SUBJECT: **Customer Satisfaction Program 17M04 - Supplement #2**
Certain 2014-2016 Model Year F-250 – F-550 and 2016 Model Year F-650 - F-750
Vehicles, With 6.7L Diesel Engine
Crankcase Ventilation Oil Separator Assembly

Customer Satisfaction Program 17M04 - Supplement #2

FIGURE 1

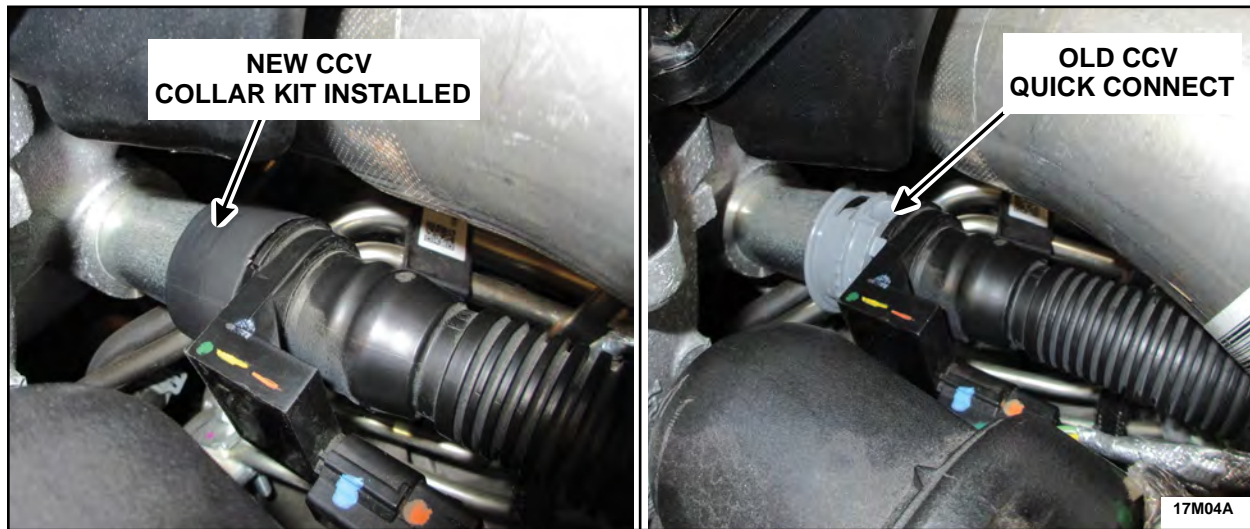
1. Using IDS check for the following DTC's: P04DB, P04E2, and P04E3.
 - If one of more of the DTCs are present, install a CCV collar kit.
 - Reprogram the PCM Using IDS R110.01 or Higher.
2. If none of the above DTCs are present, and a CCV collar kit is not already installed on the CCV oil separator assembly, and reprogramming the powertrain control module (PCM) is required for another concern, the dealer will install a CCV collar kit on the CCV oil separator assembly. If a CCV collar kit has previously been installed on the CCV oil separator assembly, this program does not apply. See Figure 1.

⚠ WARNING: Do not proceed with a calibration update if the CCV collar kit has not been installed at the crankcase vent oil separator outlet hose to the intake manifold connection. The CCV collar kit is a permanent connection and has a black in color smooth sleeve around the outside of the collar with no visible locking tabs. The previous level quick connection lock ring may be gray or black in color and includes visible locking tabs and raised teeth around its circumference. Failure to install the CCV collar kit permanent connection prior to flashing the PCM with a calibration update will result in violation of U.S federal and certain state emissions laws. Refer to the latest supplement for FSA 17M04 for further information regarding installation of installing the CCV collar kit.

FIGURE 2

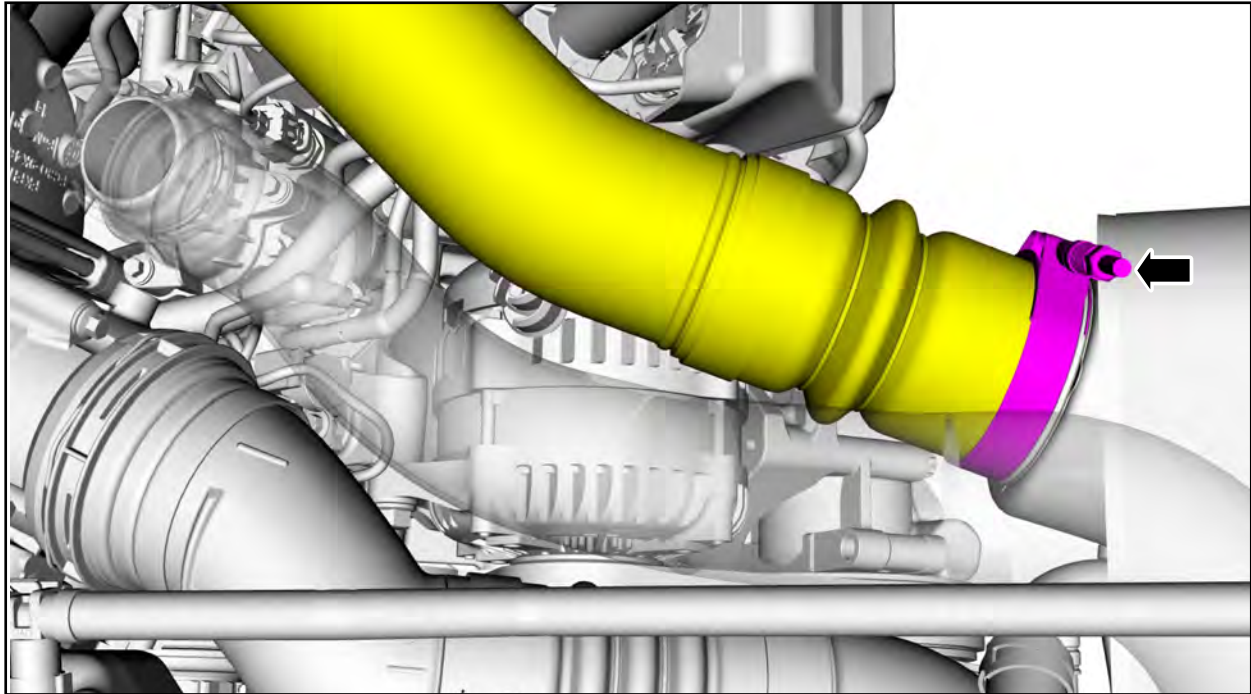
3. Loosen the clamp and disconnect the Charge Air Cooler (CAC) inlet tube from the CAC and position aside. See Figure 2.

8. Connect the Charge Air Cooler (CAC) inlet tube to the CAC and tighten the clamp. See Figure 2.
 - To install, tighten to 9 Nm (80 lb-in).

FIGURE 3

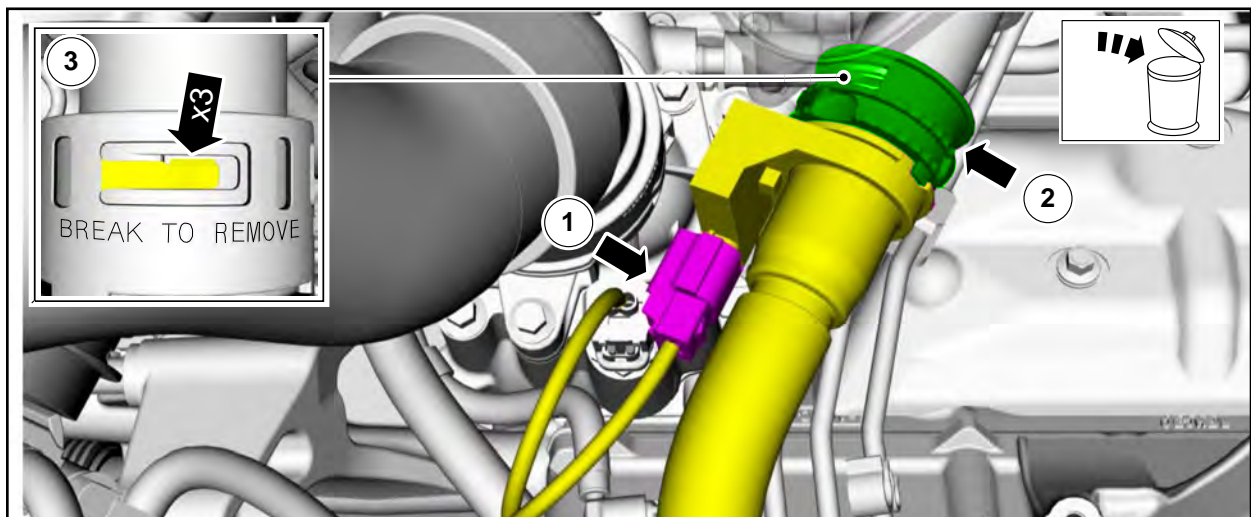
4. Remove the quick connect end crankcase vent oil separator outlet hose. See Figure 3.
 1. Disconnect the crankcase vent oil separator outlet hose sensor electrical connector.
 2. Disconnect and remove the crankcase vent oil separator outlet hose from the intake manifold by turning the release ring counterclockwise.
 3. Remove the quick connect end from the hose by twisting clockwise and pulling at the same time, break the retaining tabs as needed. Discard the old quick connect.

FIGURE 4

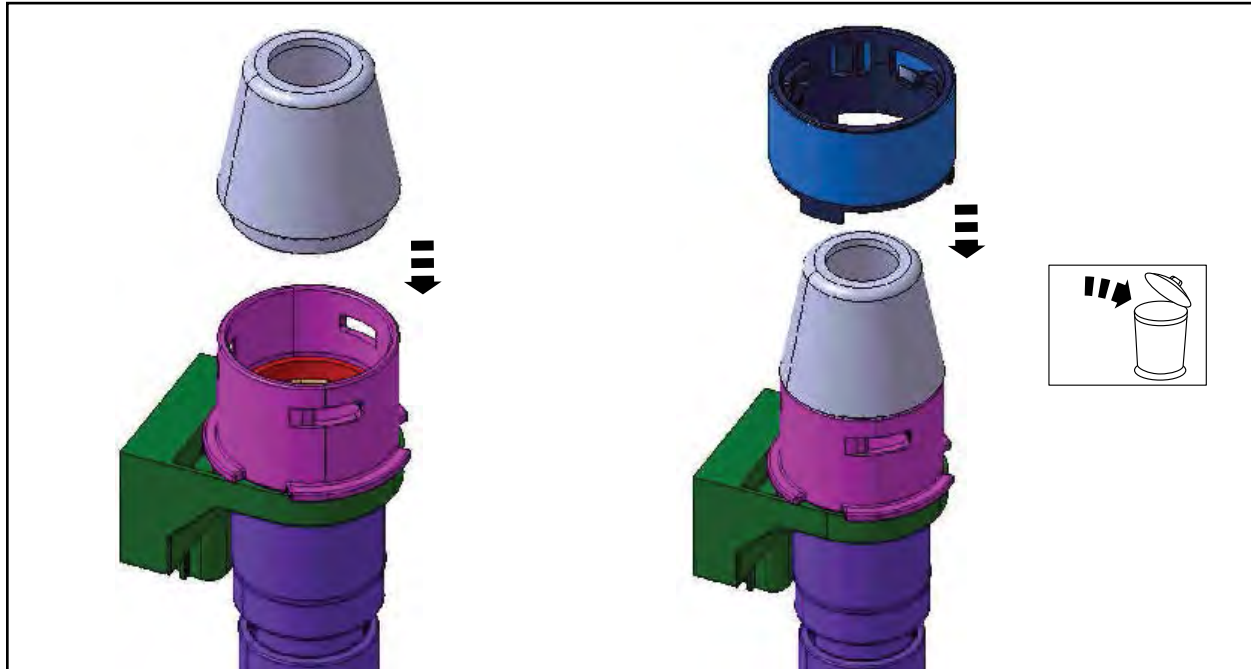
5. Place the installation cone into the end of the crankcase vent oil separator outlet hose. See Figure 4.
6. Install the *new* CCV collar over the installation cone and twist to lock into place. Remove the installation cone and discard. See Figure 4.

NOTE: The tabs on the CCV collar should be pointing down.

FIGURE 5

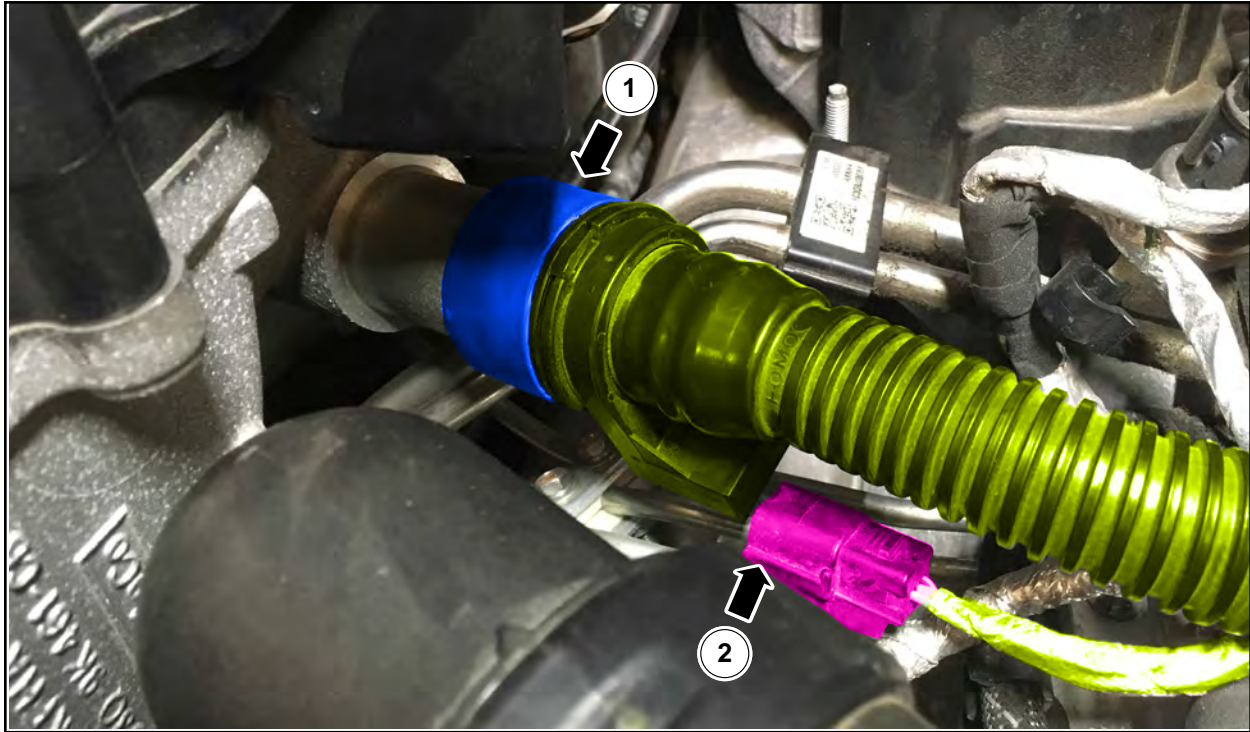
7. Connect the crankcase vent oil separator outlet hose to the intake manifold (1) and connect the electrical connector (2). See Figure 5.
